**Re: Preliminary Site Plan Review
RiverWoods Durham Phase II
Assessor's Map 209, Lot 33
Stone Quarry Drive and Dover Road
Durham, New Hampshire
Altus Project No. 5440**

Altus Engineering (Altus) is in receipt of the Tighe & Bond's (TB) review comments dated October 1, 2025. We offer the following in response:

TITLE VEHICULAR
ACCESS EXHIBIT

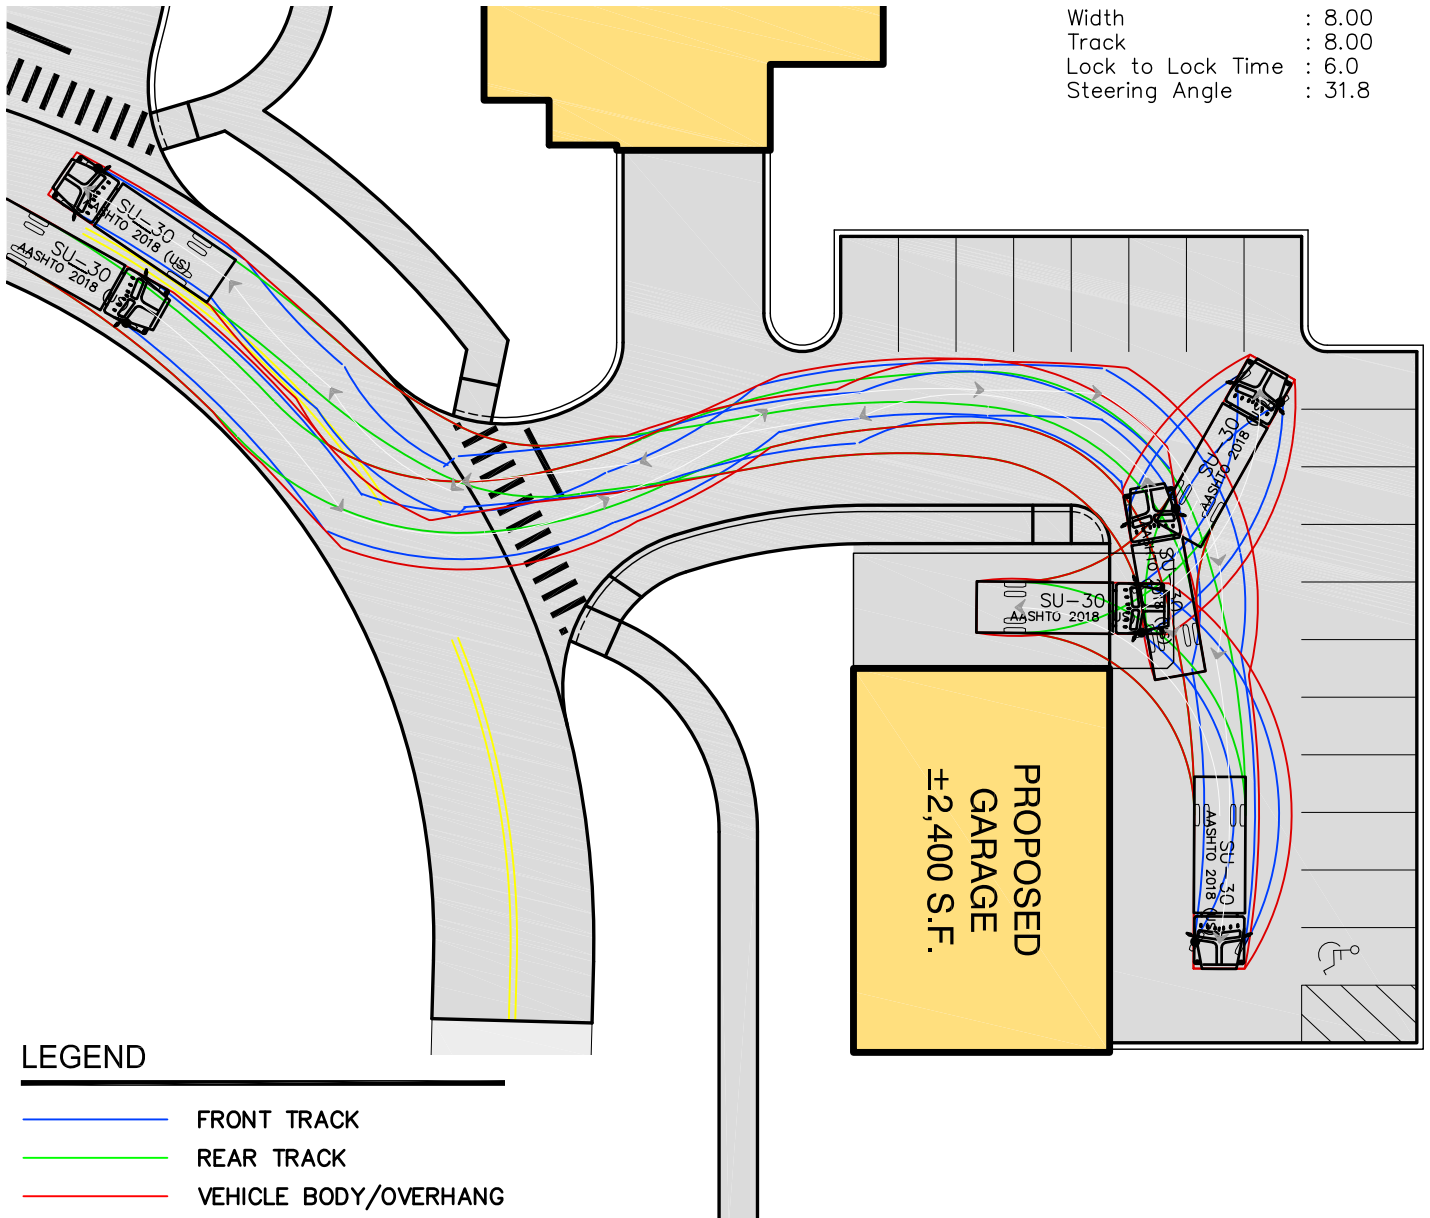
4. We have attached an exhibit showing the turning movements of a SU-30 design vehicle at the maintenance garage.
5. An ADA space has been added to the maintenance garage's parking lot.
